**City of Bellevue  
Development Services Department  
Land Use Staff Report**

**Proposal Name:** Brancato Garage and Guest Cottage

**Proposal Description:** Land Use review of a proposal to reduce a 50-foot buffer and 75-foot toe-of-slope structure setback from a steep slope critical area to construct a garage and a detached guest cottage. Temporary disturbance of a steep slope critical area is included.

**File Number:** 12-110520-LO

Mitigation & Restoration Plan

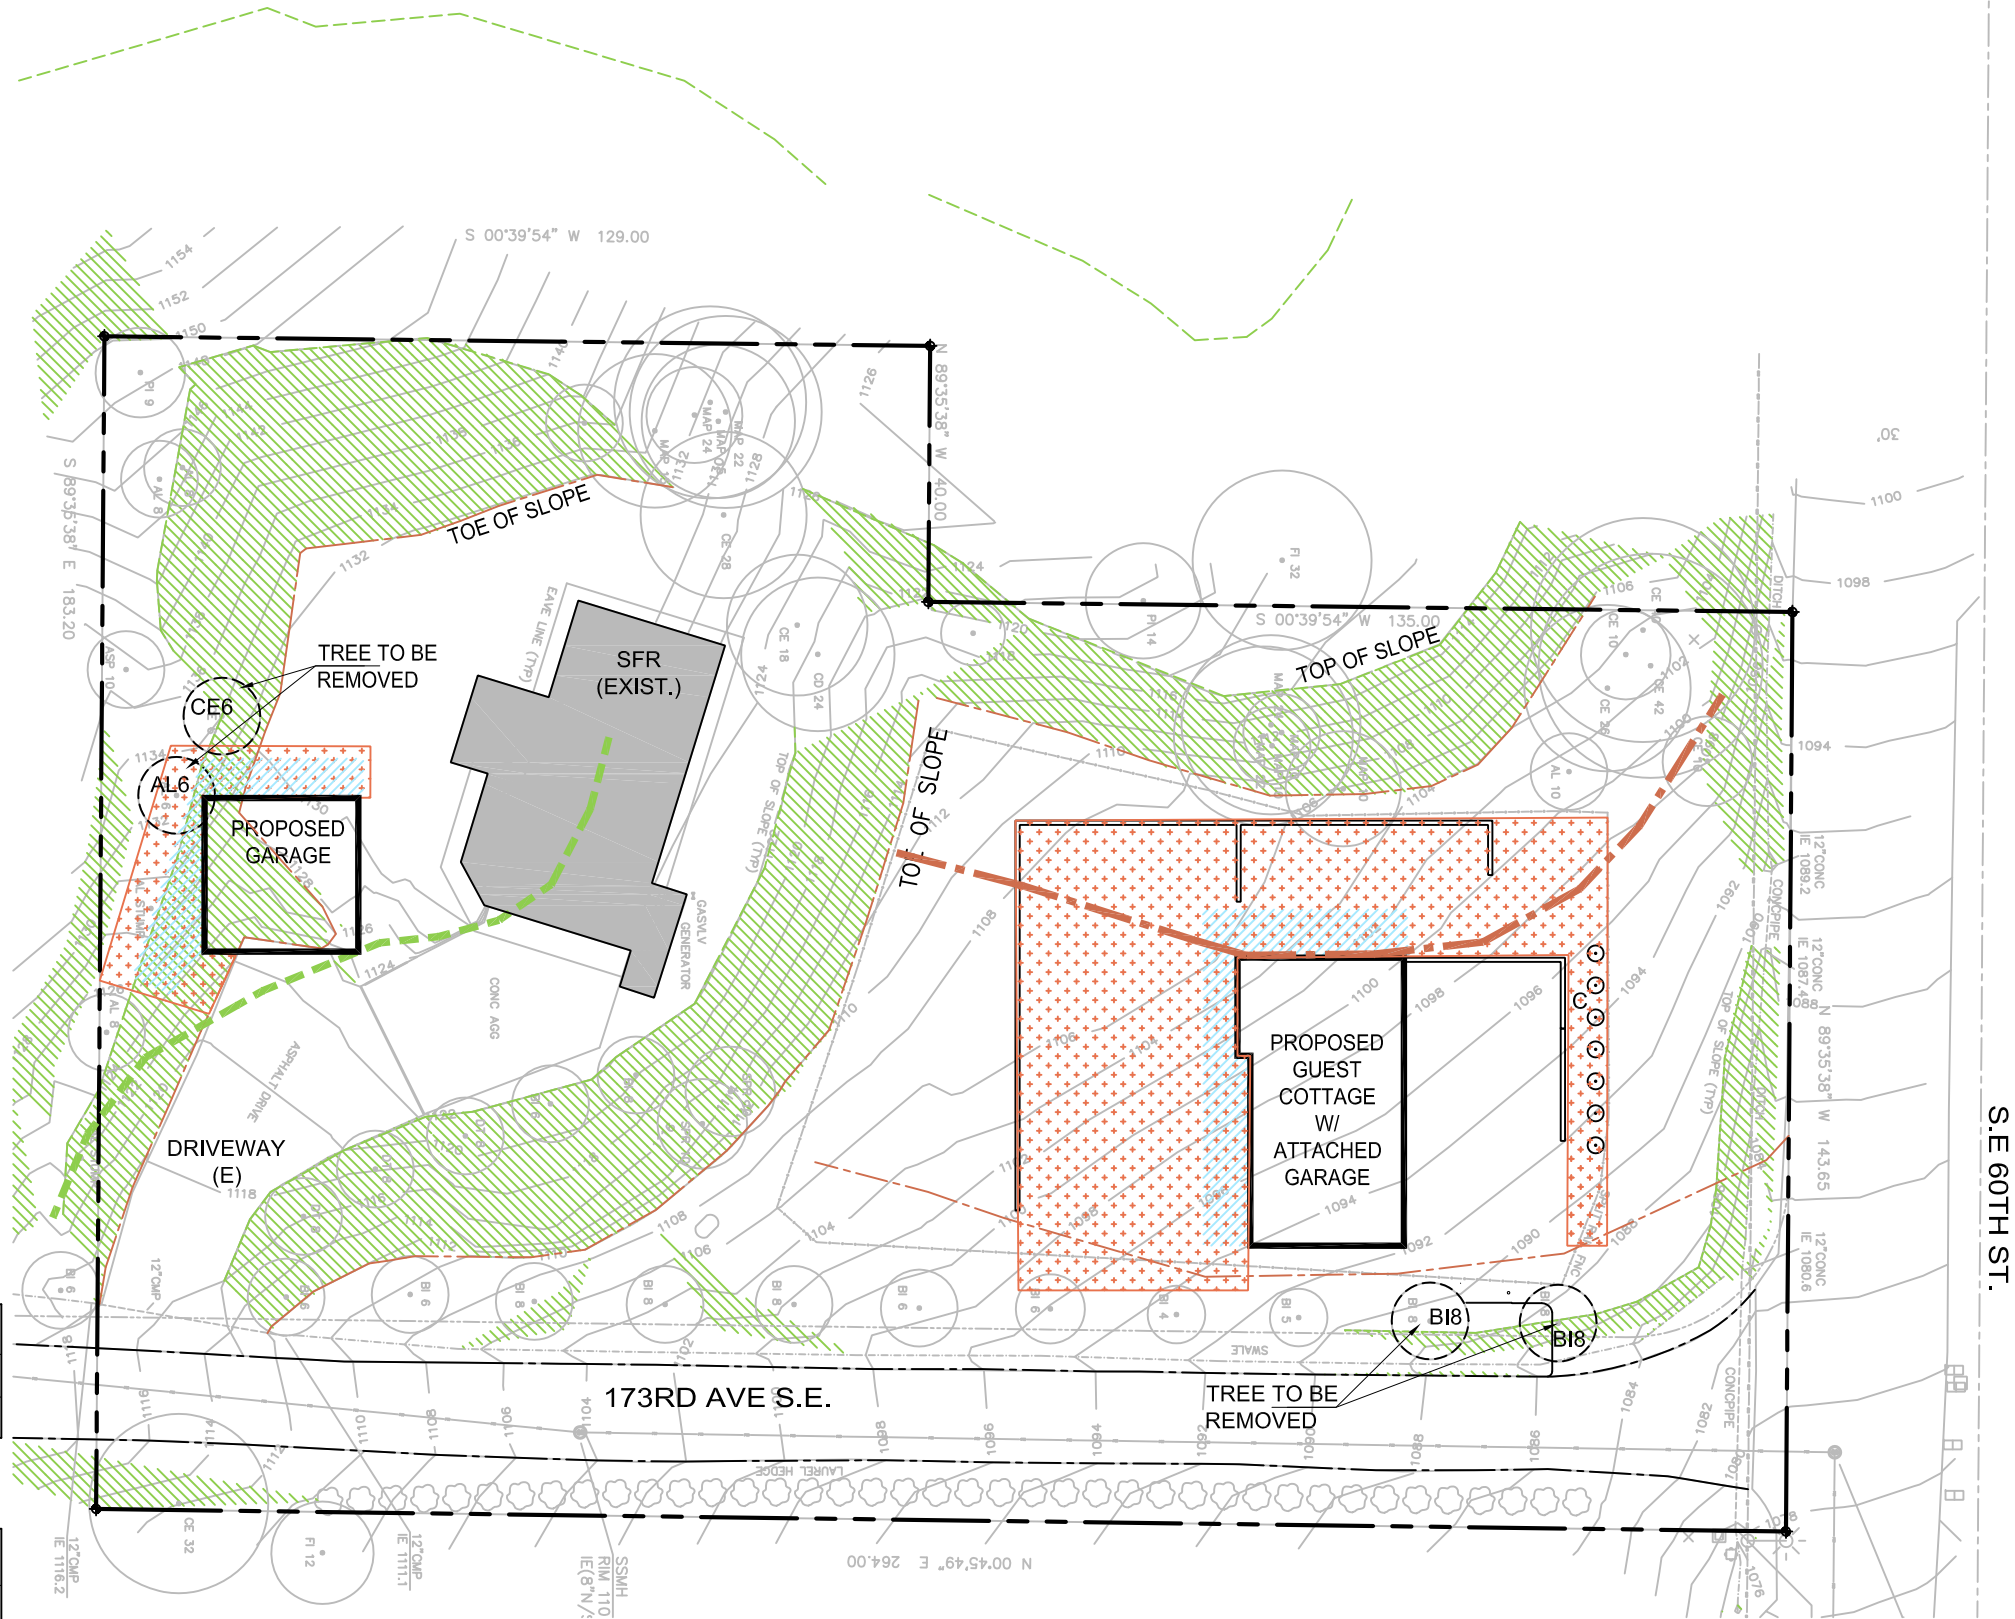
The project proposes 4,797 square feet of mitigation planting area that will provide native planting and improve vegetation cover on the slope. The planting as proposed is not sufficient and shall include trees and shrubs per the City's planting templates for steep slope areas. Based on the templates and the area of planting proposed at least 21 trees and 112 shrubs are required. The plants can be 1 to 2 gallons in size at installation. This plant density assumes at 15 on center spacing for trees and 6 foot spacing for shrubs. The planting area shall be consolidated on the site and located preferably on the steep slopes on the property or in areas of invasive plant coverage. The area of temporary disturbance should be included in the planting area. A revised planting plan is required to be submitted with the

- 4. Mitigation Planting Plan:** A revised mitigation planting plan is required as part of the building permit submittal. The plans must include native trees and shrubs per the City's planting templates and be at a similar plant density. The planting templates are Attachment 2 of this report. The planting area shall be consolidated on the site, preferably on the steep slopes areas or in areas of where invasive plants can be removed. The area of temporary excavation should be restored by the planting.
